**Walton County
The Grove**

**Change Proposal #15:
Building C & G – Revised Gas-
Line**

Walton County, GA
The Grove, a Walton County Parks & Recreation Facility

Change Proposal #15: Building C and G – Revised Gas Line

P-1.1C

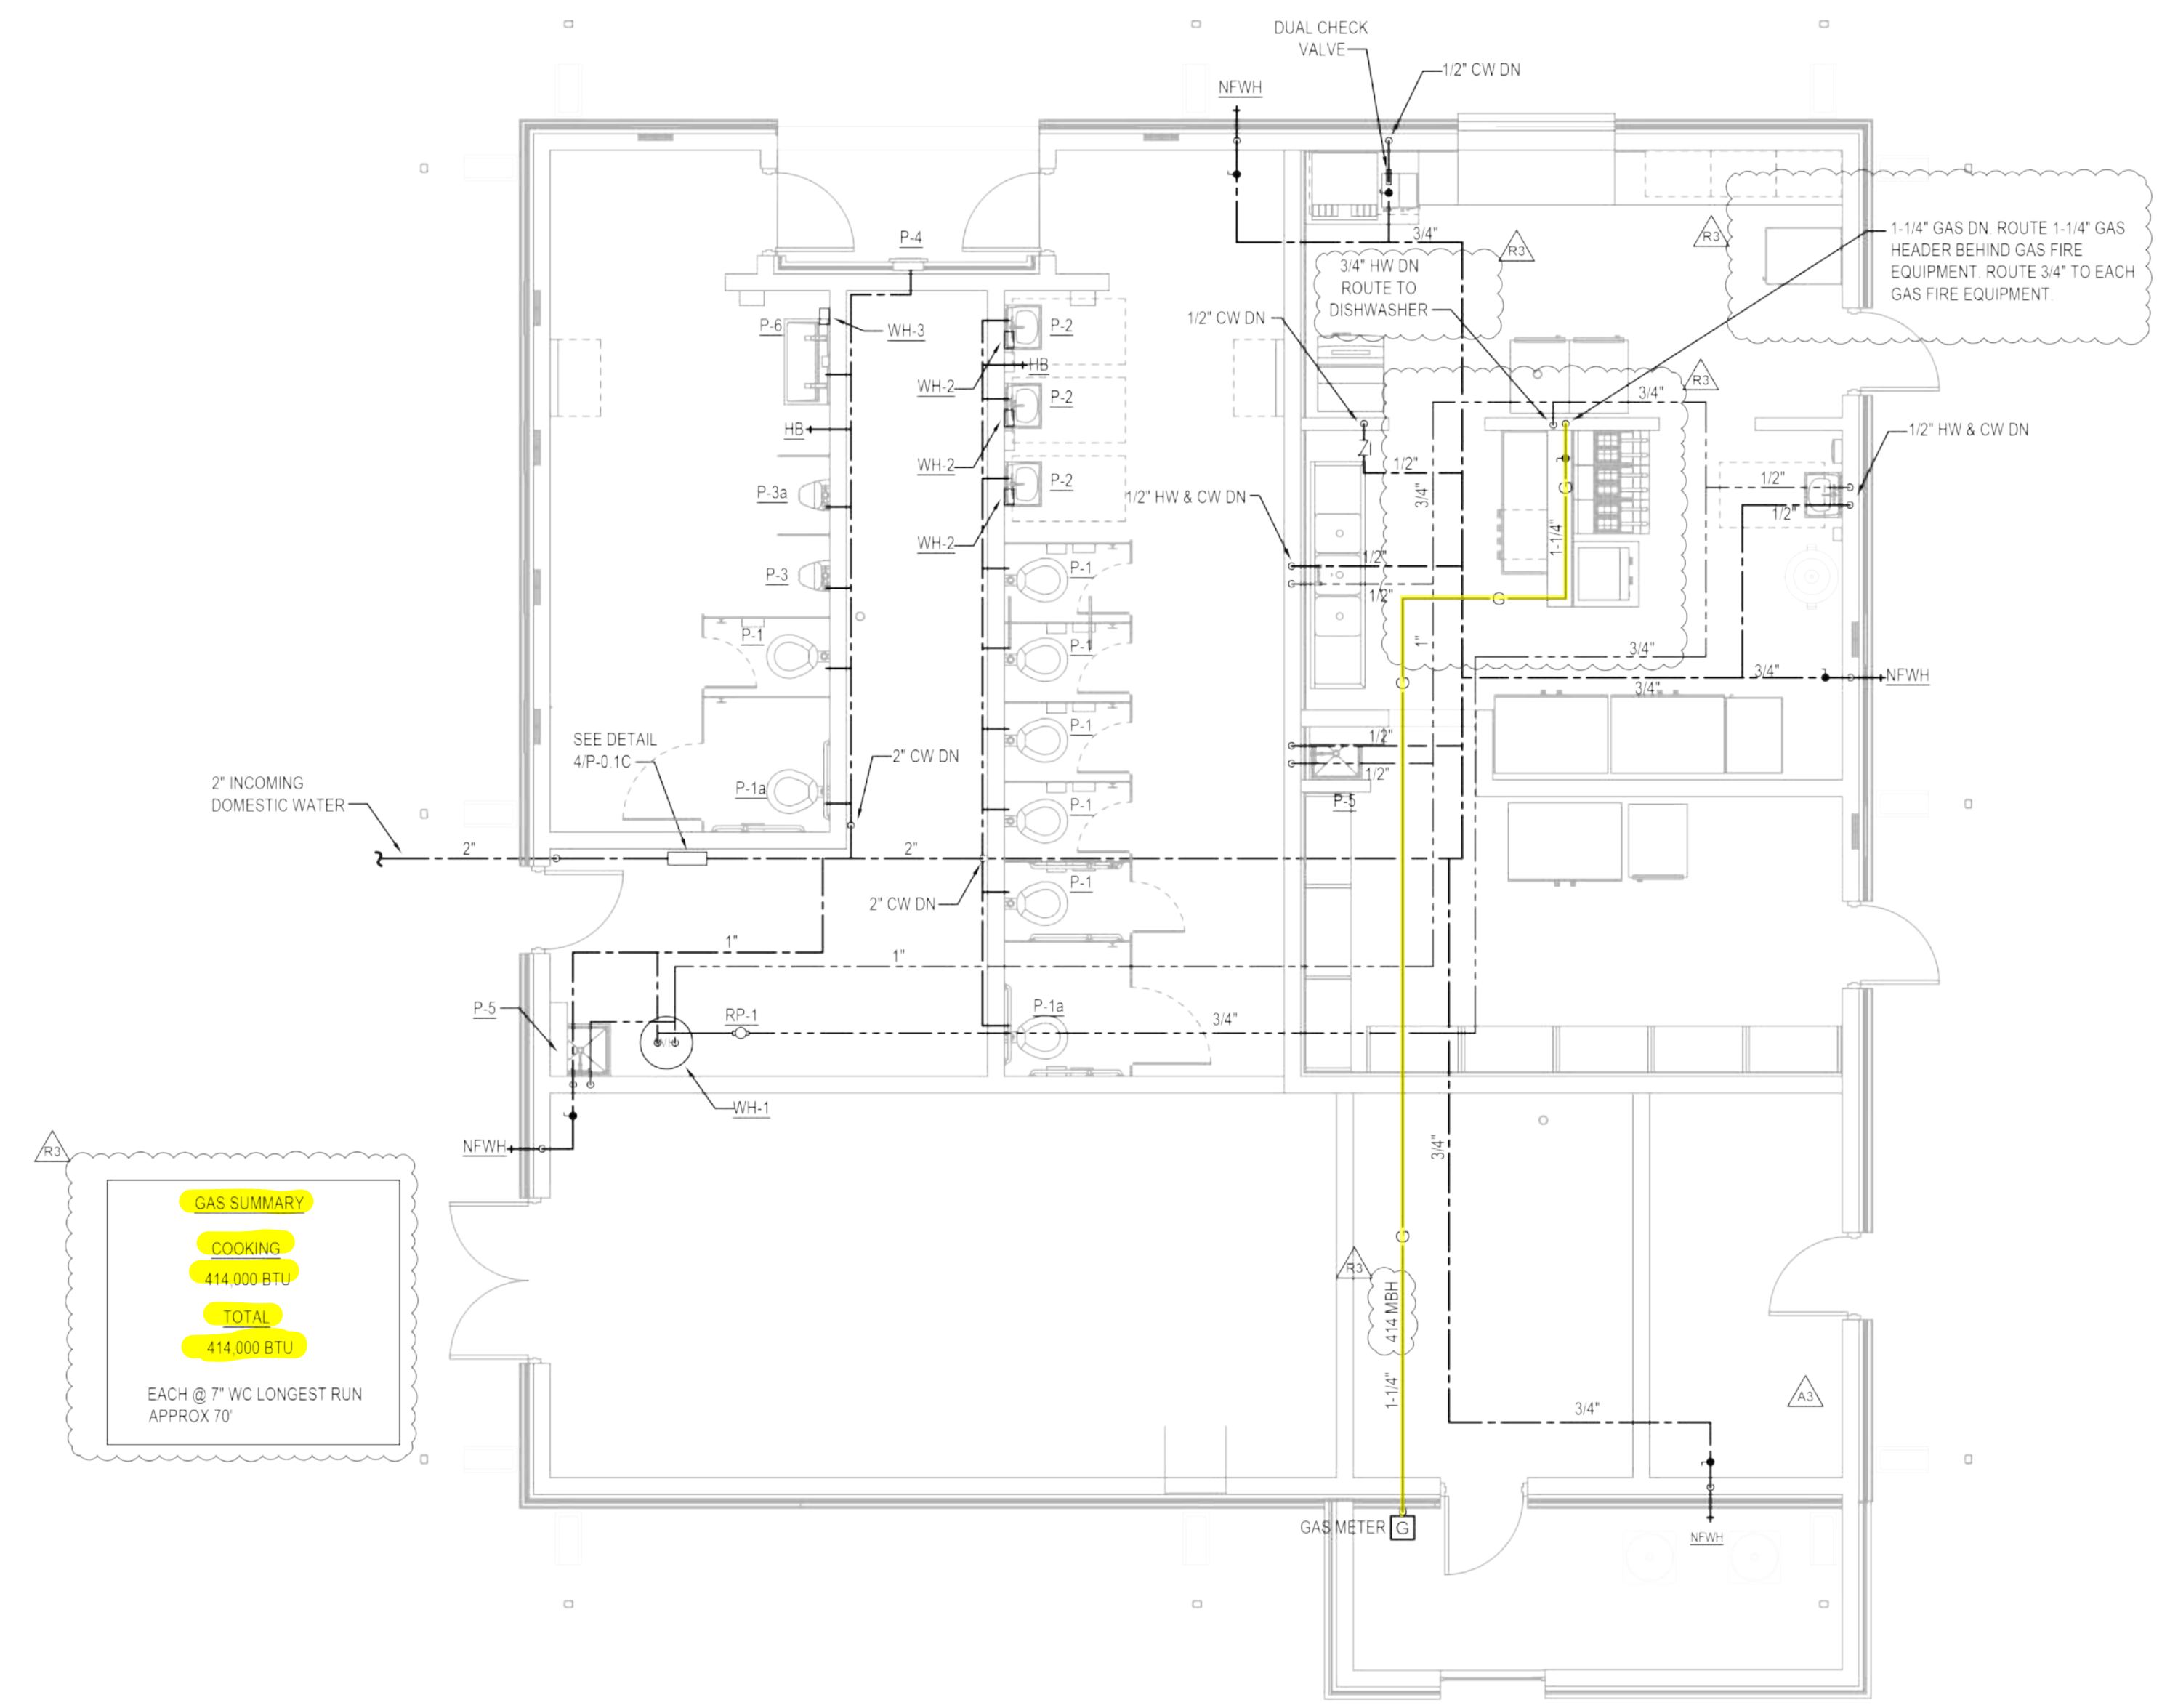
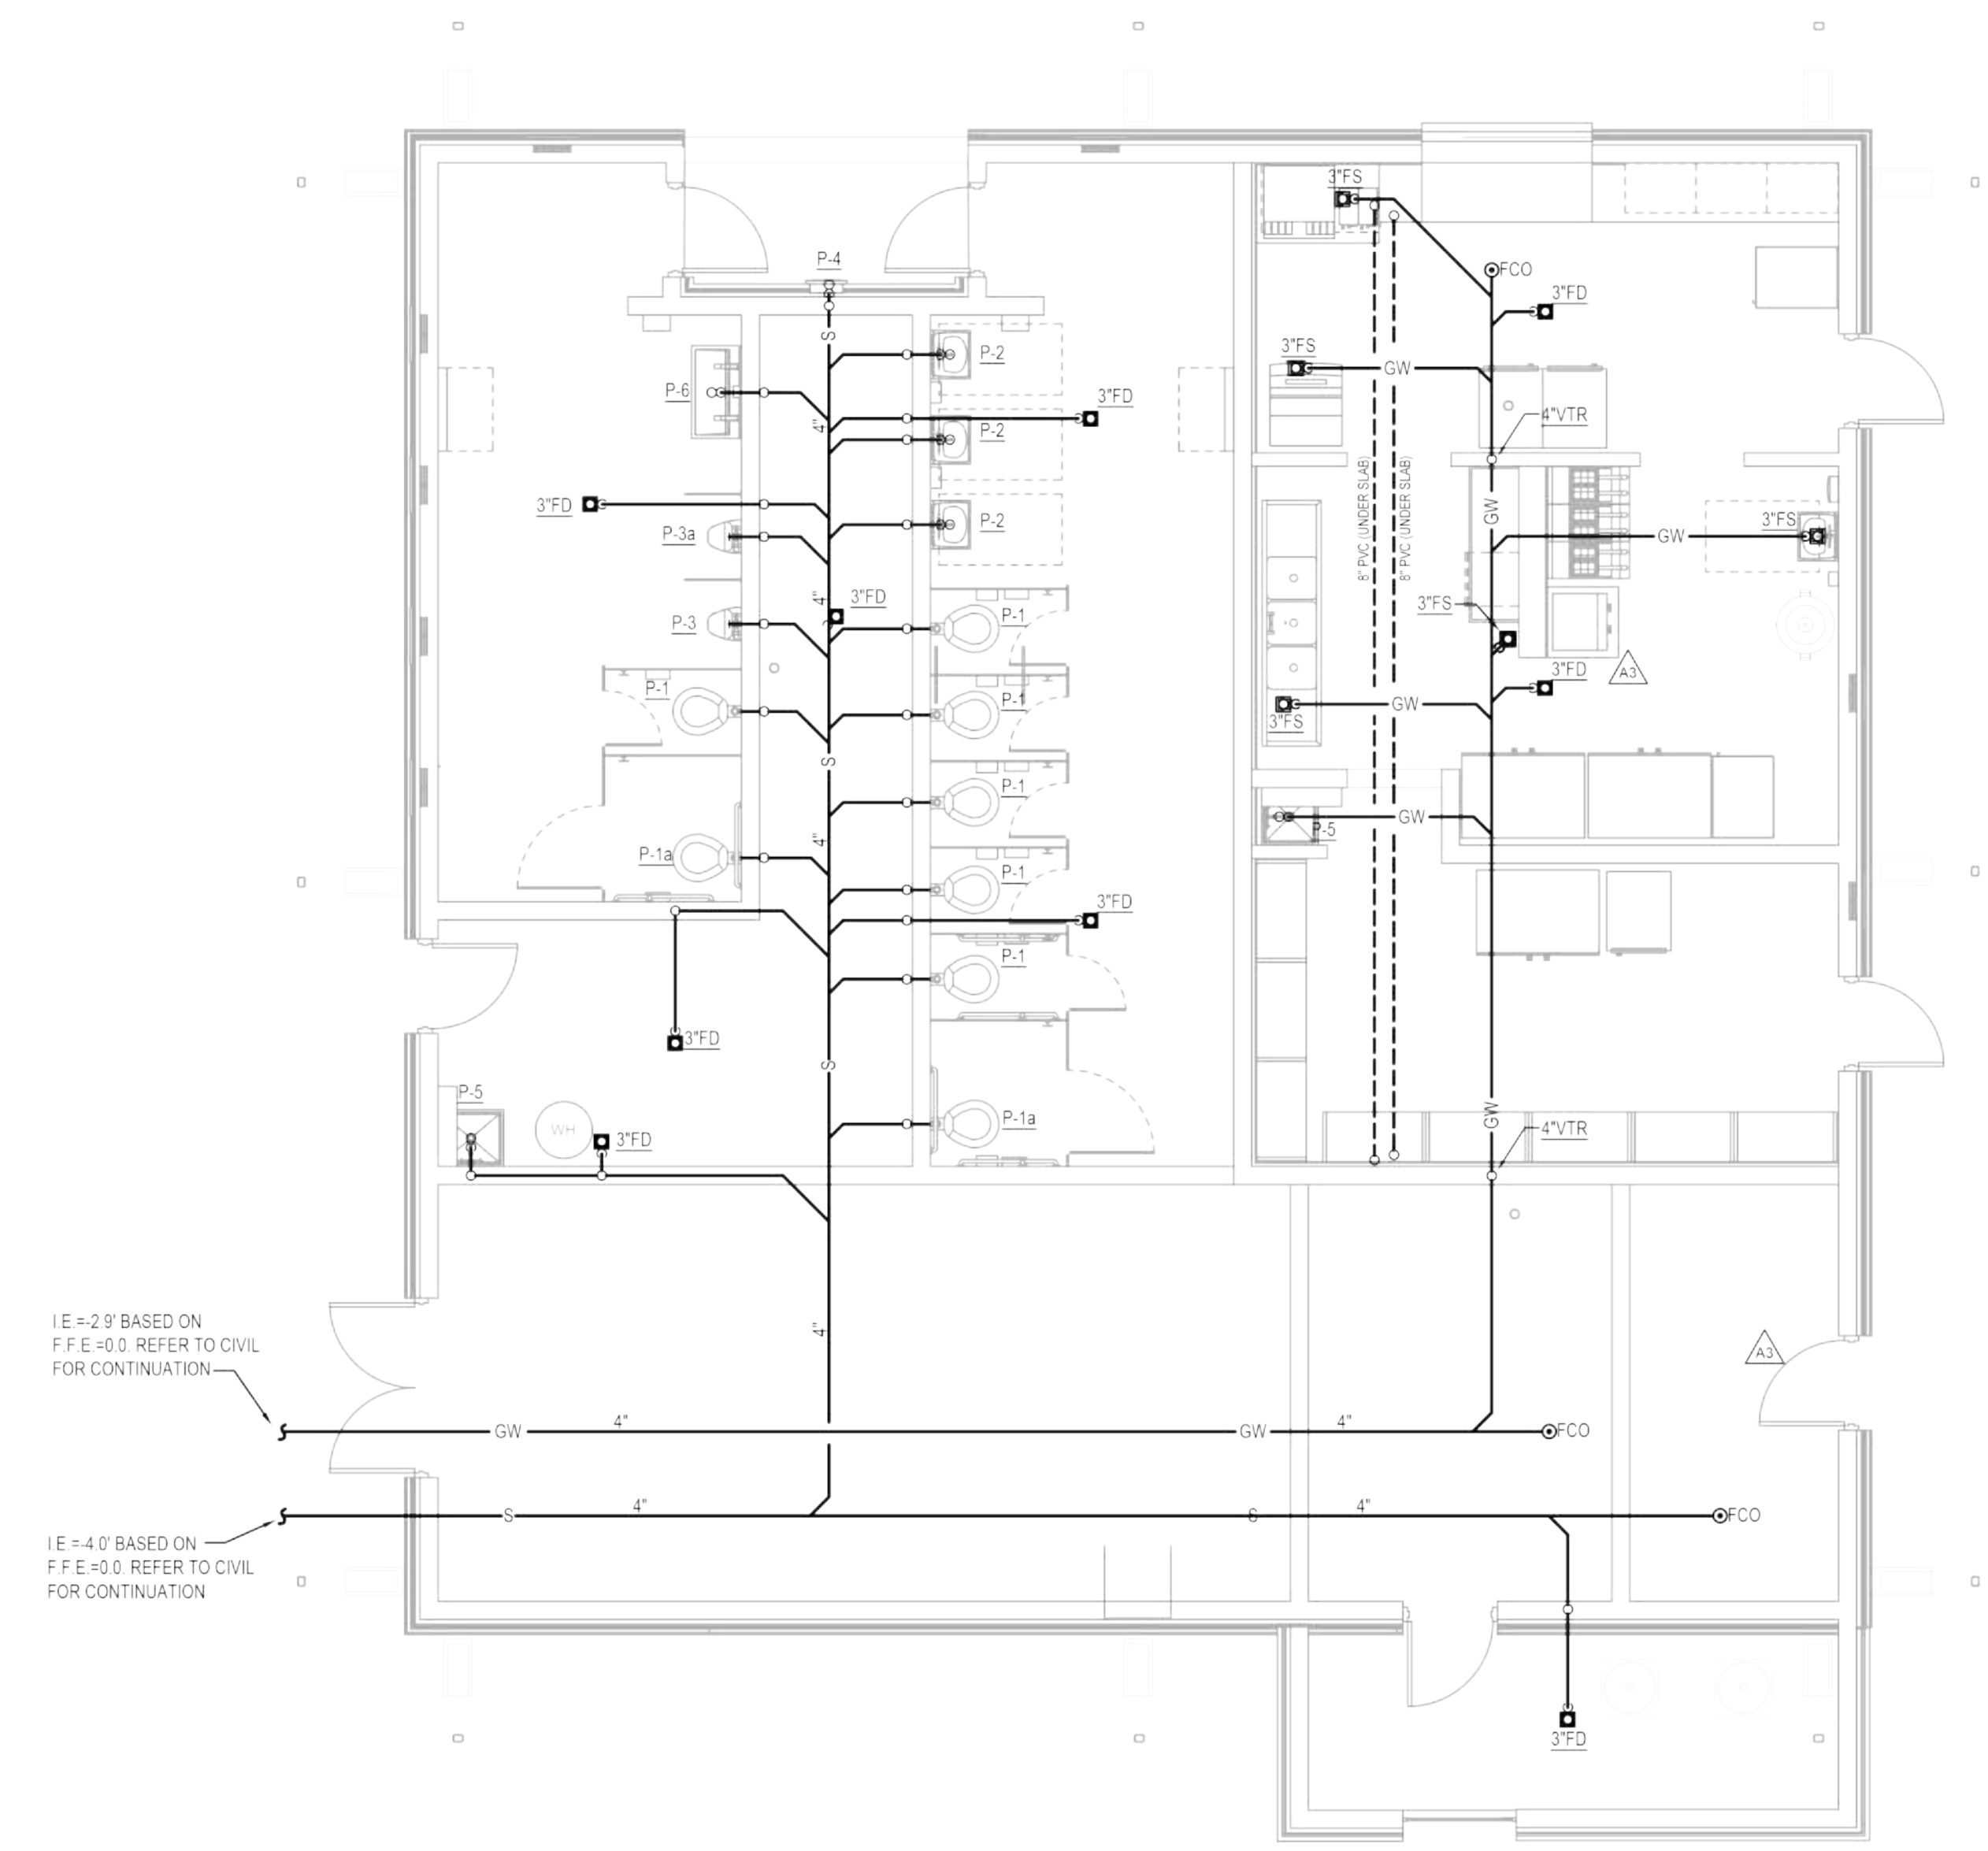
Our mechanical subcontractor noted that the Gas Summary on sheet P1.1C for Building C potentially does not include the gas load for mechanical equipment, nor does it show any connections to any mechanical equipment.

Based on their calculations, the total gas load would be 763,400 BTU which would require a 2" gas line instead of the 1-1/4" line specified on P1.1C.

Please confirm the total gas load. See the attached documents for reference.

Savant response: The gas load needs to increase to 736,400 BTU and the incoming gas line needs to be 2". A 3/4" gas line can be ran to each HVAC equipment.
